# UNITED STATES PATENT AND TRADEMARK OFFICE

09/541,857

# Office Action Summary

### **DETAILED ACTION**

FIG. 1A

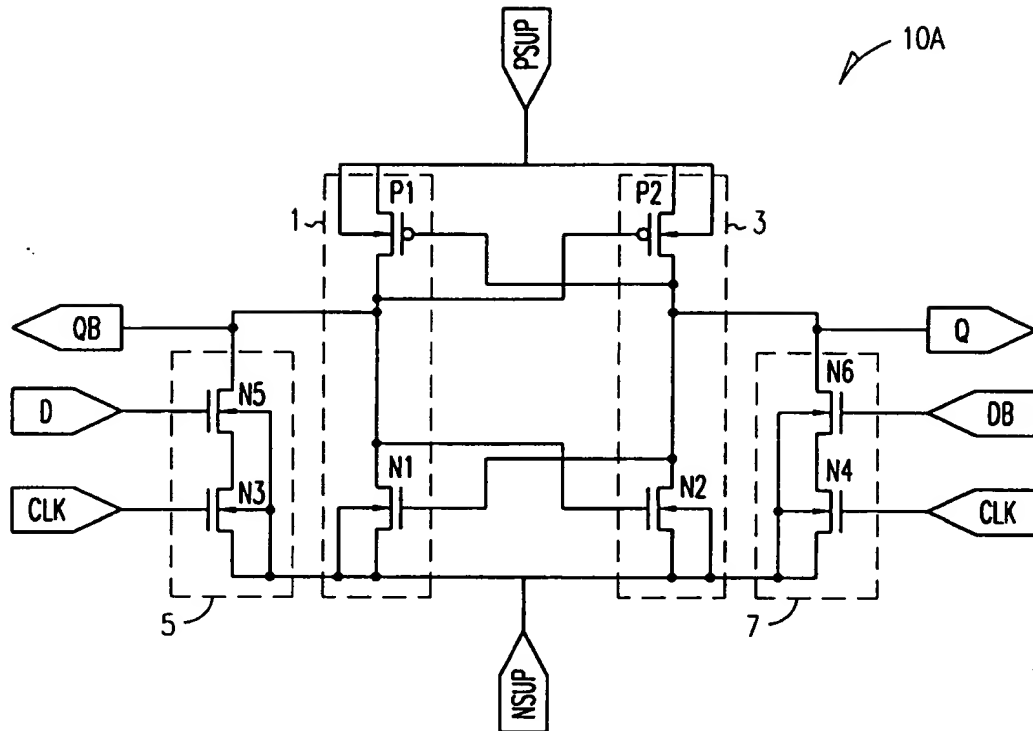
In FIG. 1A, reference number "10" is amended to "10a."
